**Marbach Pump Station Improvements (Volume I) &
Mission Road Service Center Drainage (Volume II) (RFCSP)
Solicitation Number: CO-00533
Job No(s): 20-6001/21-2501**

**ADDENDUM 6
September 27, 2023**

TYPICAL CANOPY
FOUNDATION AND
ELECTRICAL EQUIPMENT
SUPPORT DETAIL

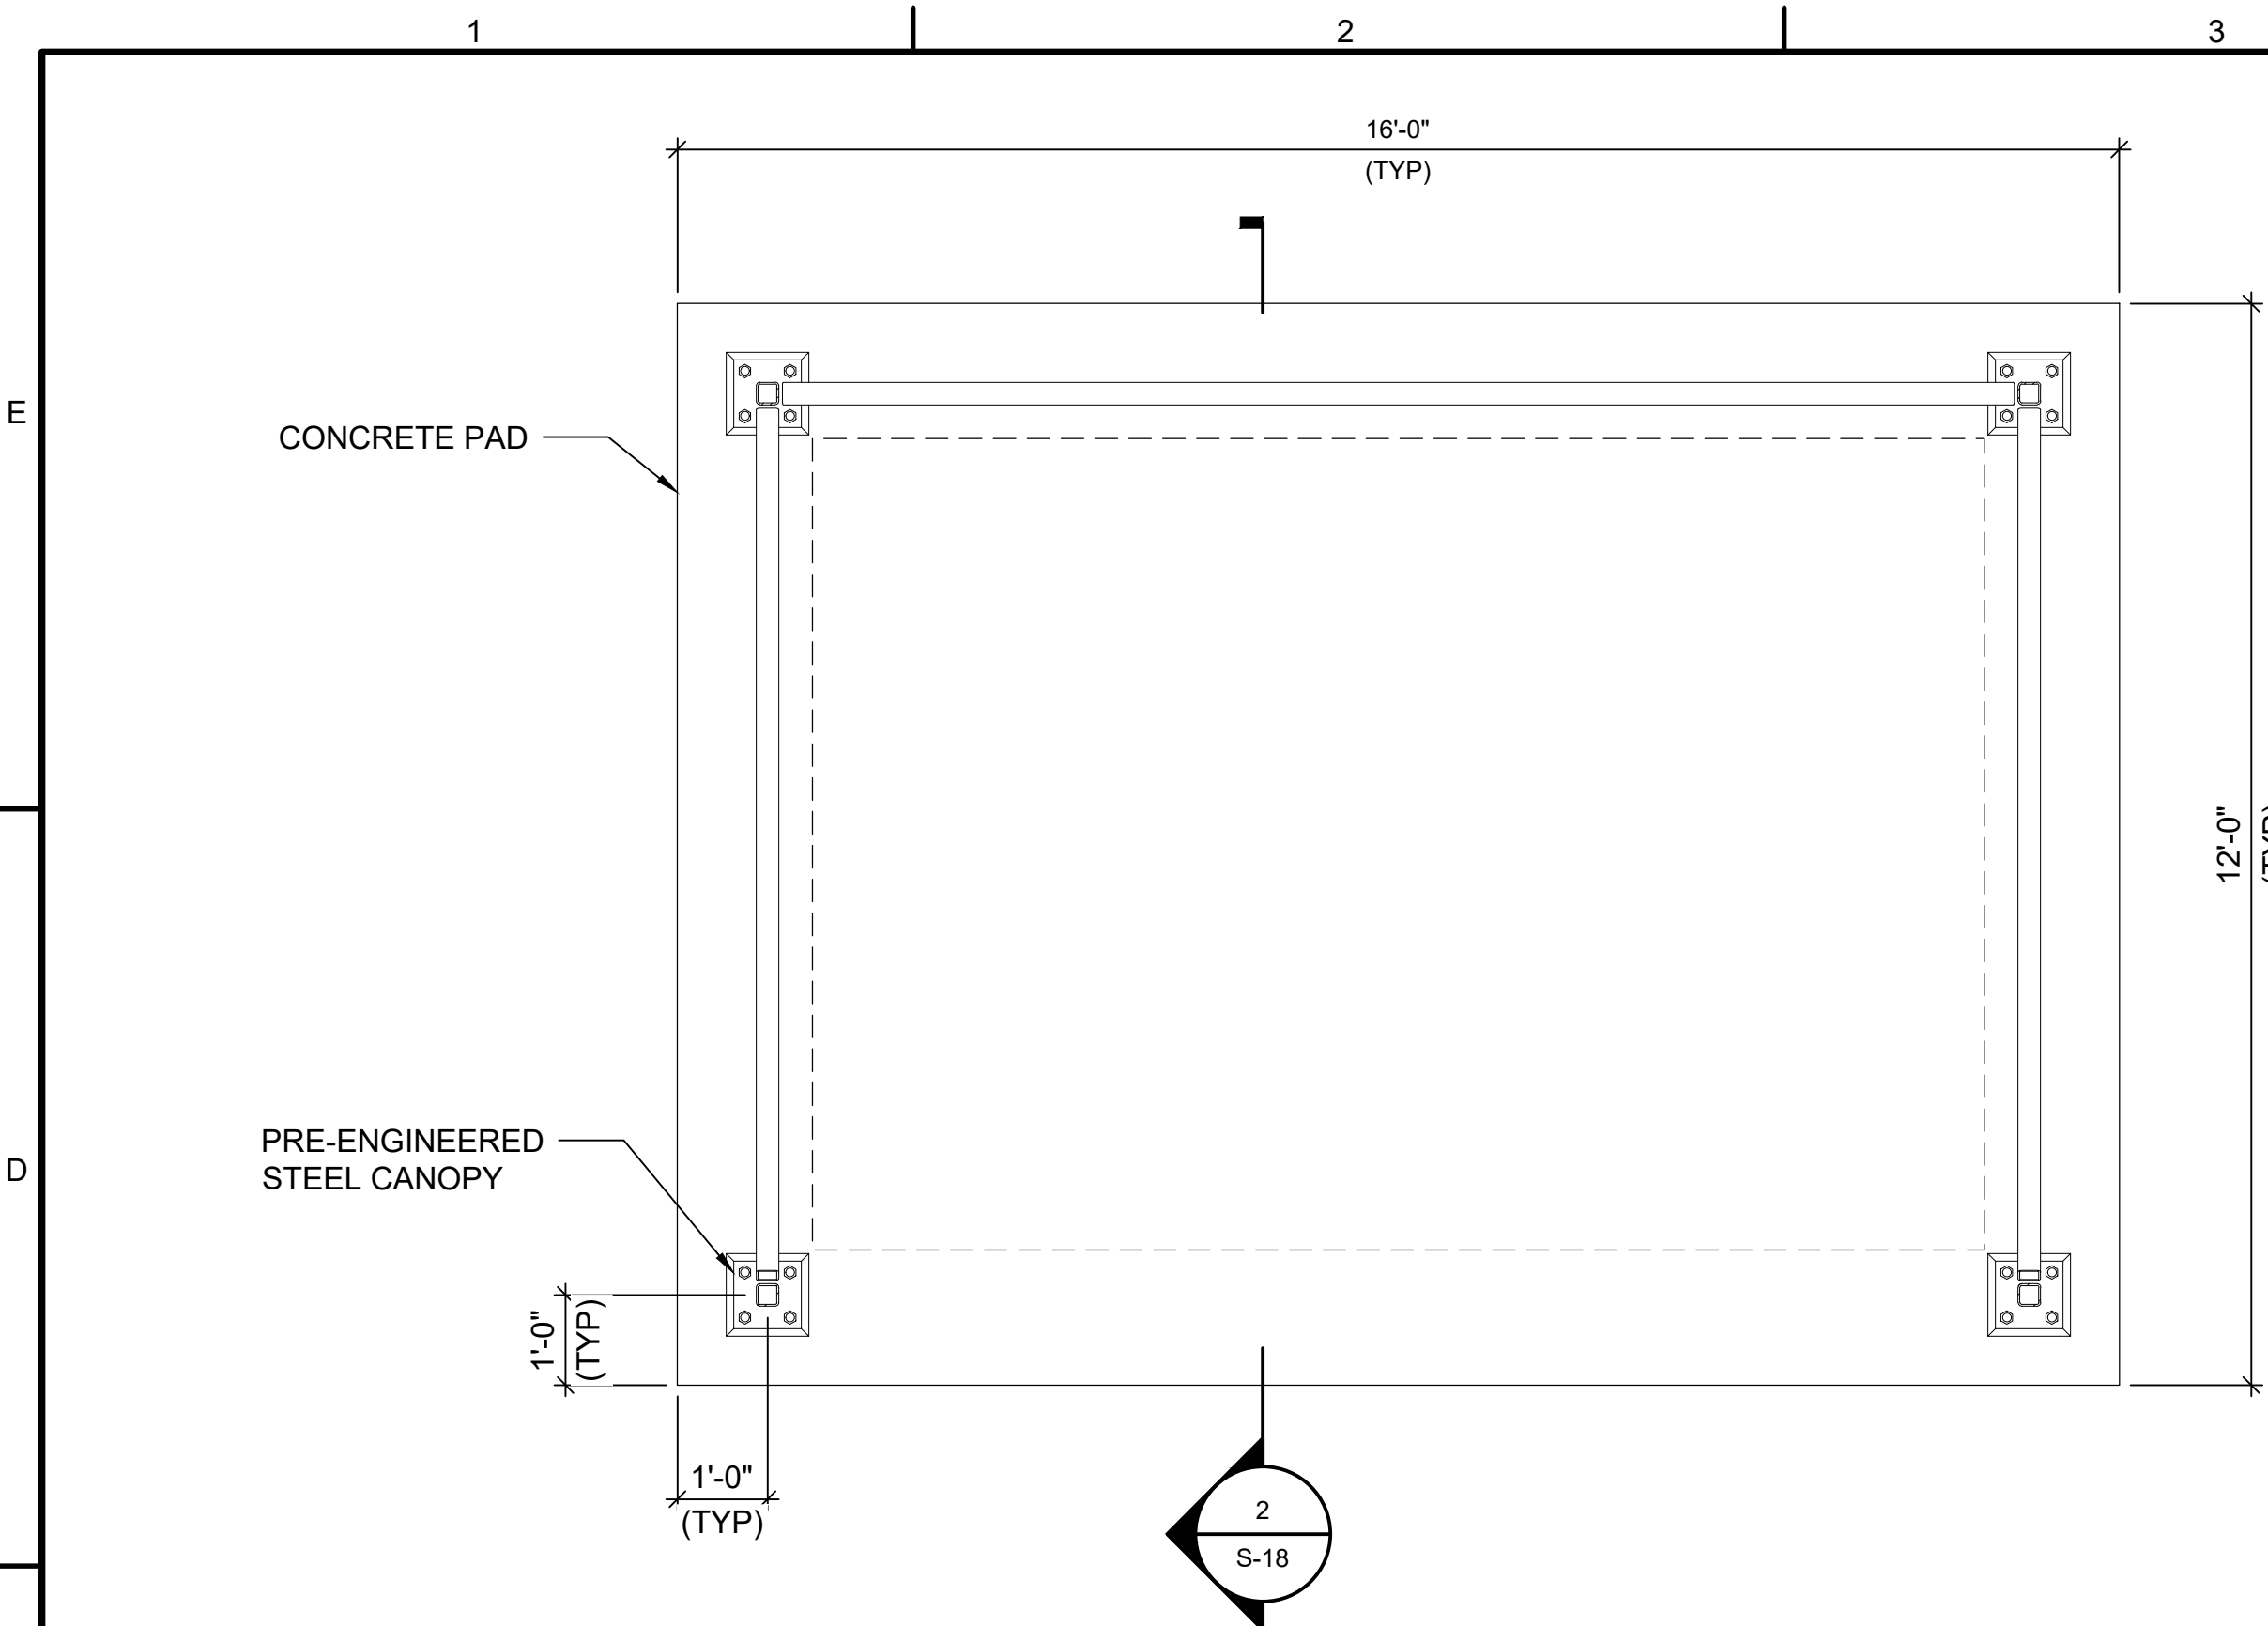
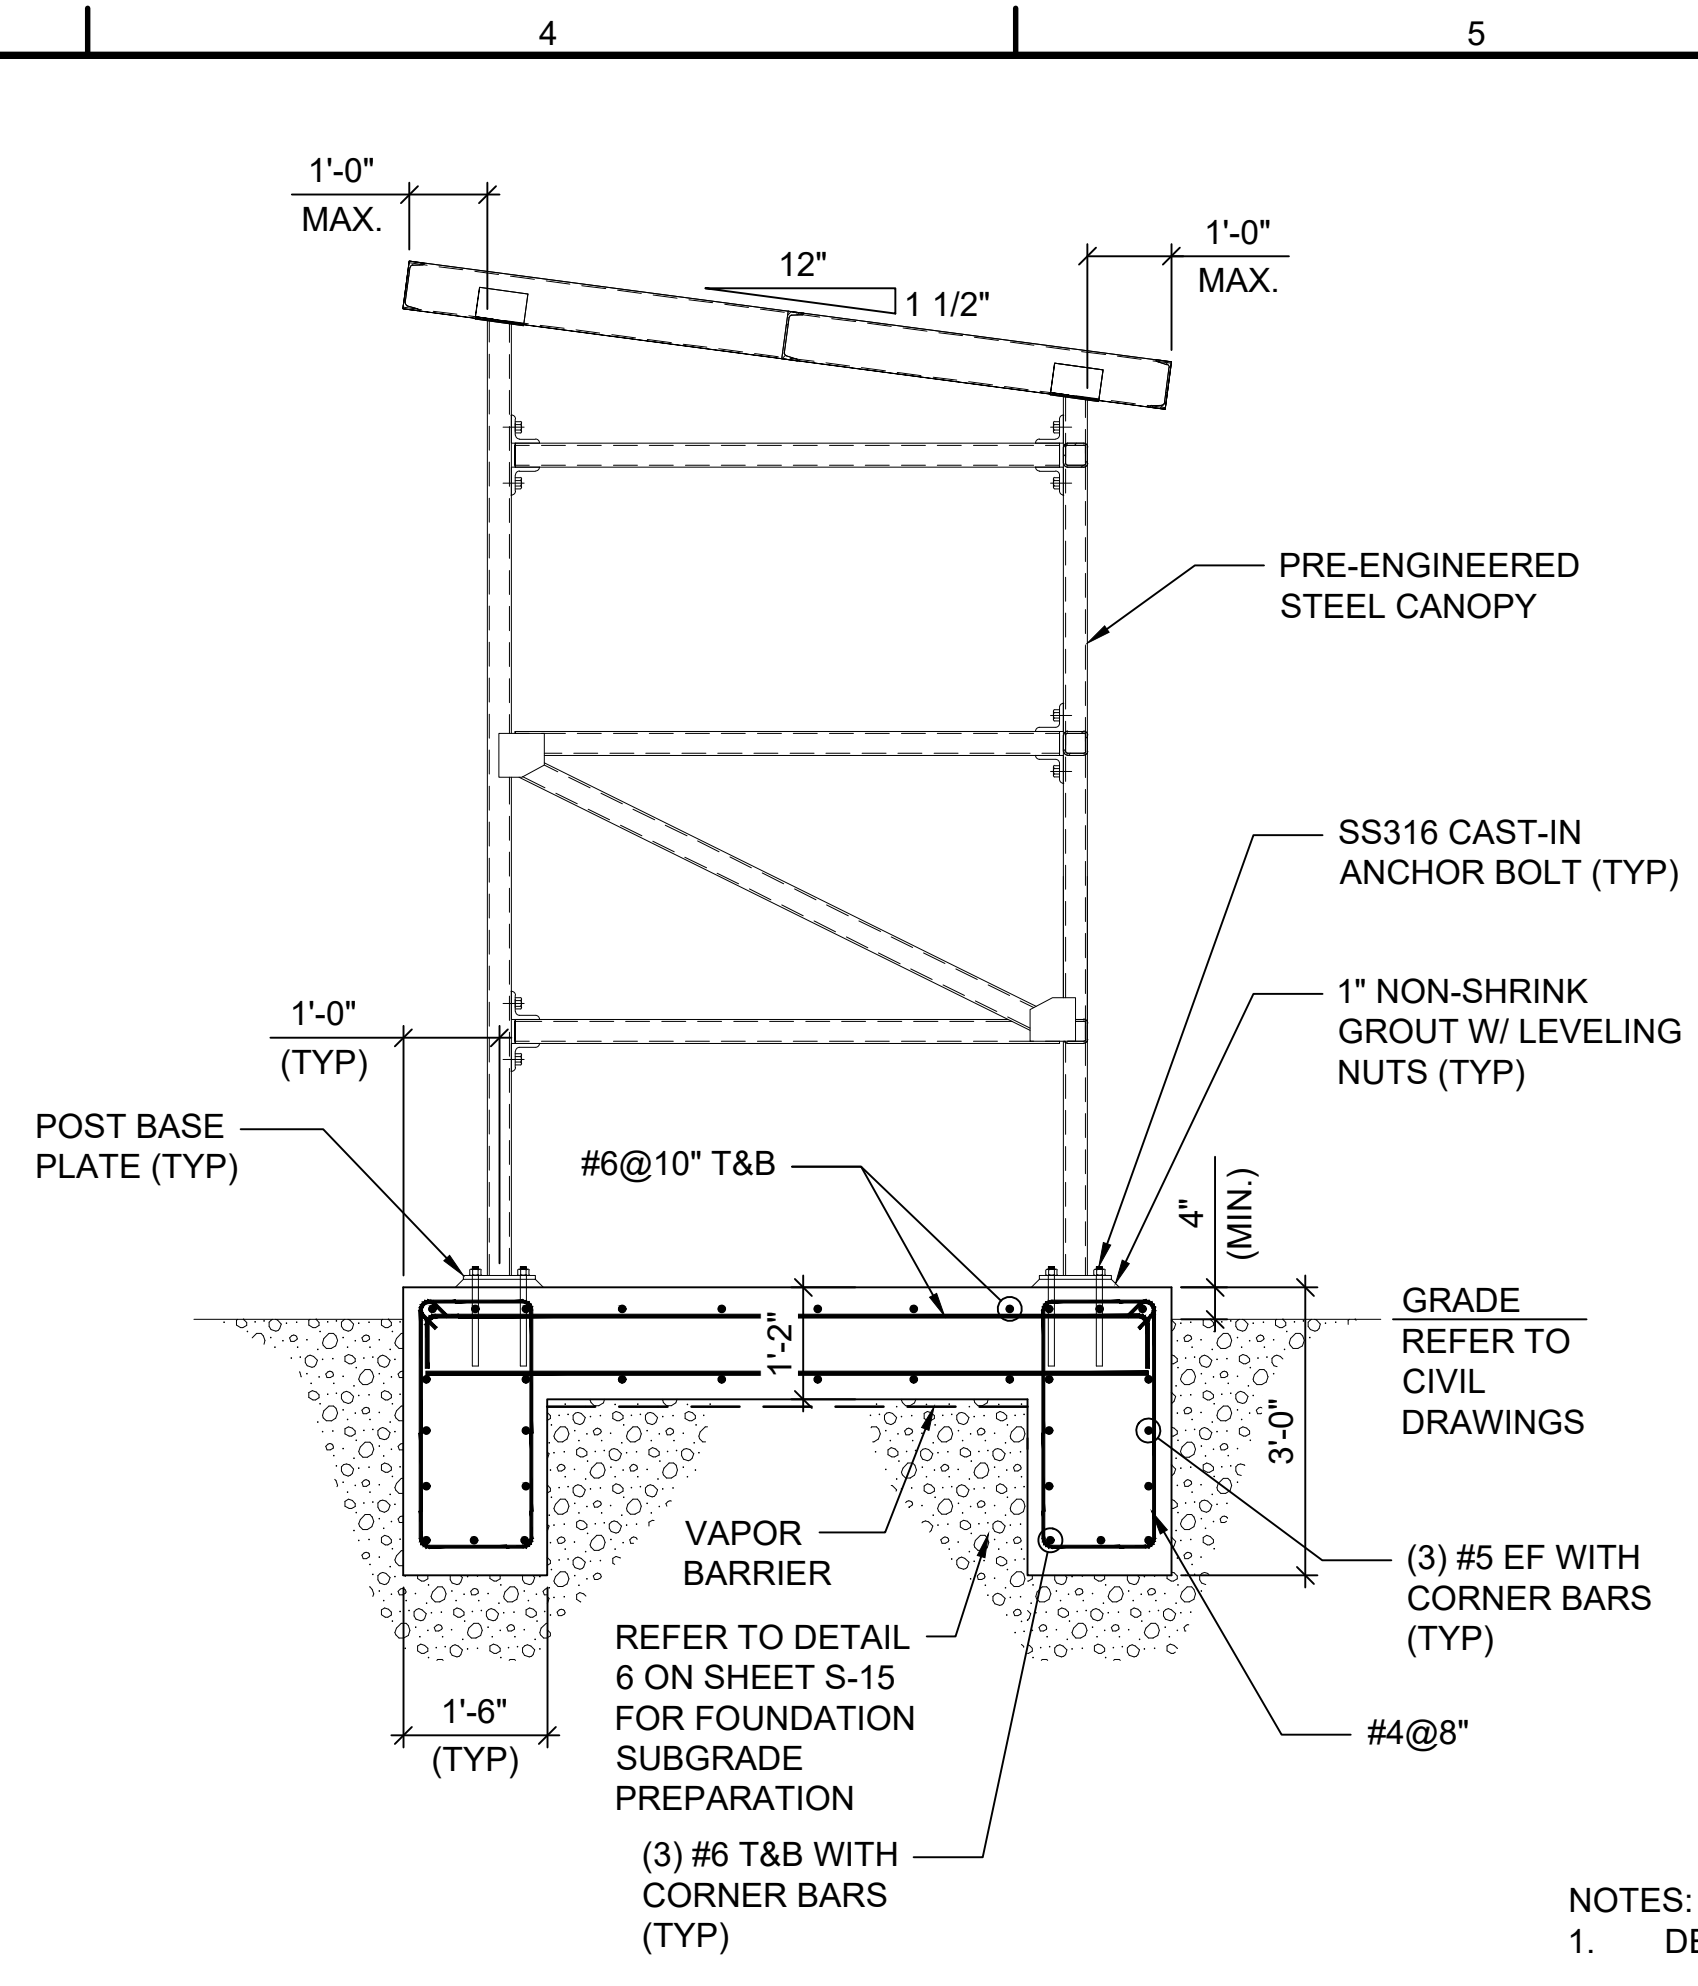
- 46. Question: Can a spec be provided for door canopies shown on the architectural elevations sheet A-07?**

Response: Additional information has been included in the plans. See Item Nos. 3, and 4 in the CHANGES TO THE PLANS section of this addendum.
